Addendum #1

April, 2015

SHEET TITLE: PARTIAL FLOOR PLAN		CLIENT: ONTARIO ABORIGINAL HOUSING SERVICE PETERBOROUGH, ONTARIO		PROJECT: THE FIREHOUSE COMPLEX 721 MONAGHAN ROAD PETERBOROUGH, ONTARIO	
SEAL:  GREGG GORDON LICENCE 3920	DRAWN BY: JR	PROJECT # 14047	Gregg Gordon Architect Tel. (705) 876-6548 Fax. (705) 876-9206 516 Hunter Street West Peterborough, Ontario K9H 2N1	DWG #:	REV #:
	CHECKED BY: GG	SCALE: 3/16" = 1'-0"		SK-1	-
	DATE: APR 2015

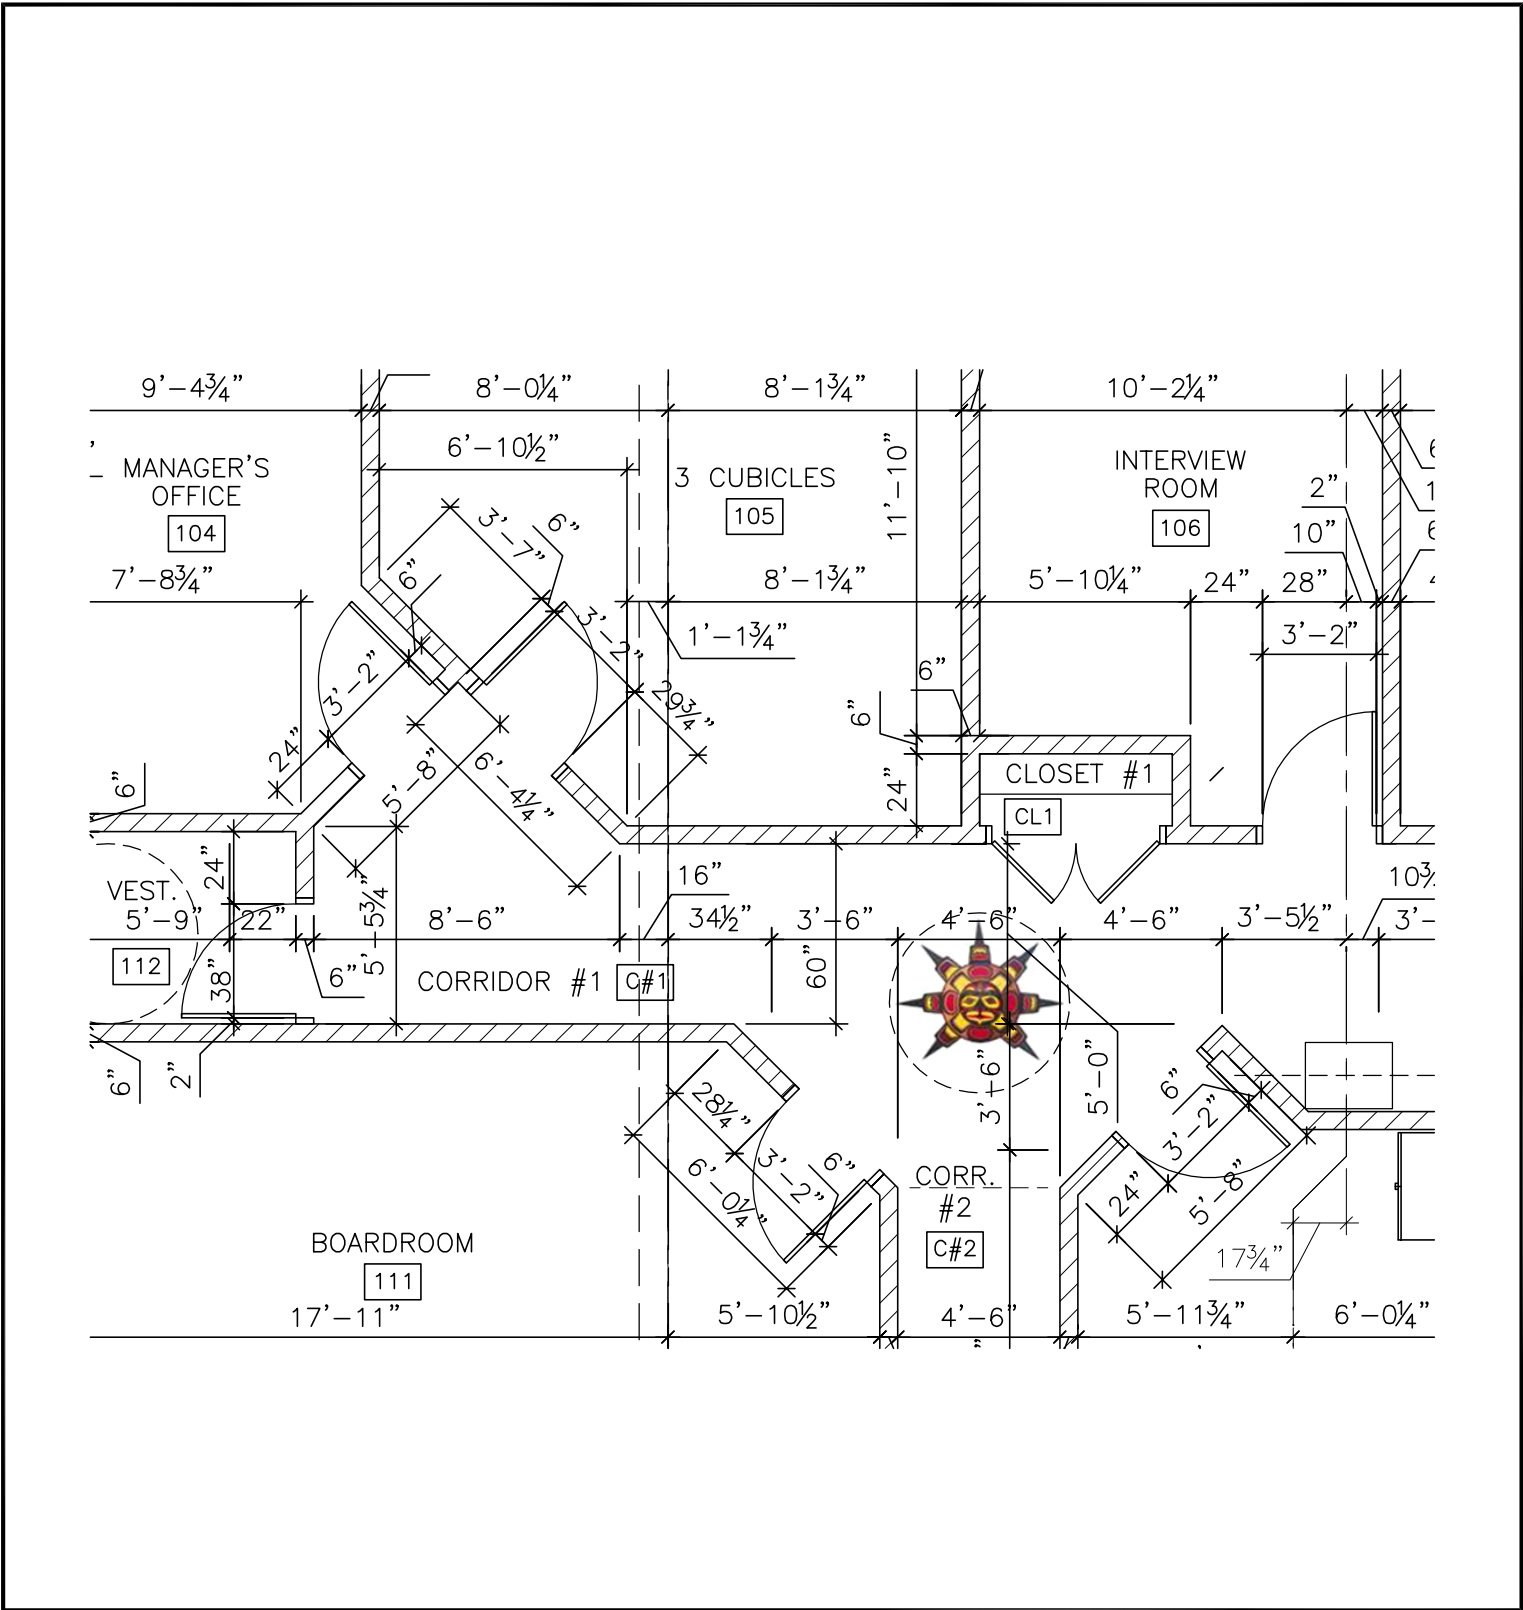
1. Modify the location of several walls in the Office Administrative Area, in order that the doors to the various rooms can be provided with a clearance from the strike side of the door to the nearest wall of 300 mm on the push side and 600 mm on the pull side. See attached SK-1 drawing.
2. The two Washrooms in the Administrative Office are to both be Unisex Washrooms and require a male and a female symbol on the two doors to these two Washrooms. On the door to the larger of the two washrooms, Washroom #115, provide also the international symbol for "Barrier Free" for mounting on the exterior side of the door.

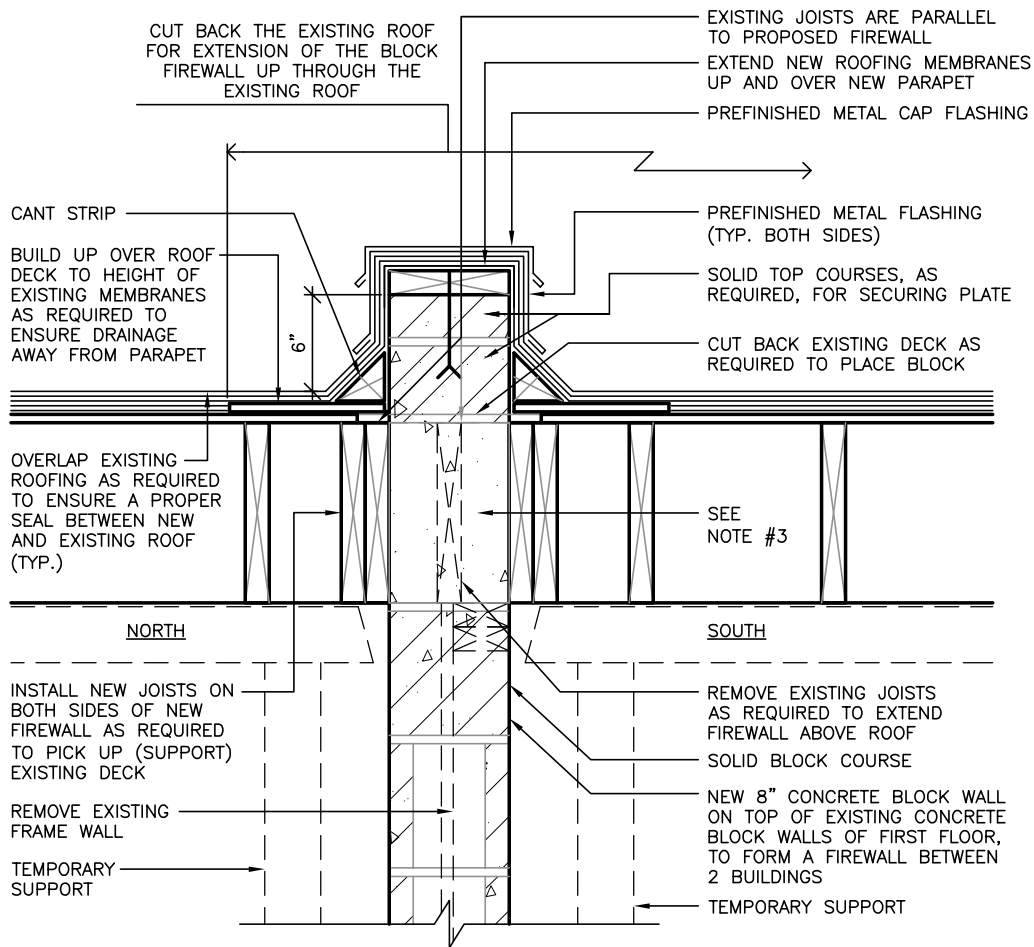
1. Details of the Firewall, where it penetrates the existing roof, were not provided in the original set of drawings. Attached are details SK-2 and SK-3 that illustrate the two conditions: one where the existing roof joists are parallel to the Firewall and the other where the roof joists are perpendicular to the Firewall.
2. See also a modified Structural Drawing S-2, for reinforcing to be provided in the firewall at the roof level.

- NOTES**
1. USE HOLLOW OR SEMISOLID CONCRETE BLOCK FOR FIREWALL, THAT CAN PROVIDE ON ITS OWN 2 HOURS (120 MINUTES) OF FRR. SUBMIT TEST RESULTS OF BLOCK TO BE USED FOR APPROVAL.
 2. FILL BLOCKS WITH MORTAR, AS SHOWN.
 3. POUR TYPE L2 CONCRETE (EXPANDED SLAG, EXPANDED CLAY OR PUMICE) INTO FORM CREATED BY BLOCKING AT HEIGHT OF JOISTS.
 4. NEW ROOF (MEMBRANE) SOUTH SIDE OF "FIREWALL".
